Remarks

Drawings

Amendments to the Drawings

FIG. 2
(PRIOR ART)

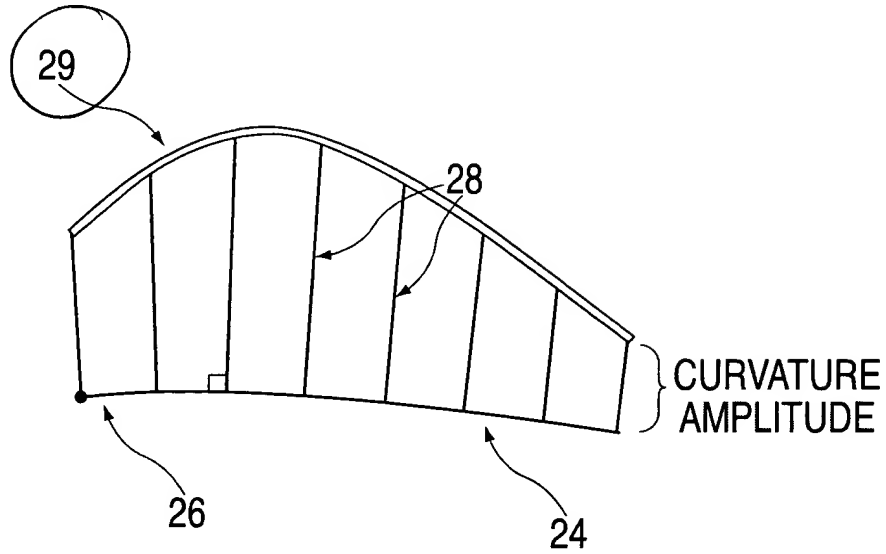
Replacement sheets showing Figures 2 through 14 have been provided herewith. The replacement drawing sheets (i) correct shading errors noted by the Examiner, and (ii) in Fig. 2, replace the reference numeral "30" with the numeral "29."

In Fig. 2, the reference numeral 30 has been replaced by the numeral 29. An amendment providing a corresponding change to the specification has also been made in this Response.

Was "30"
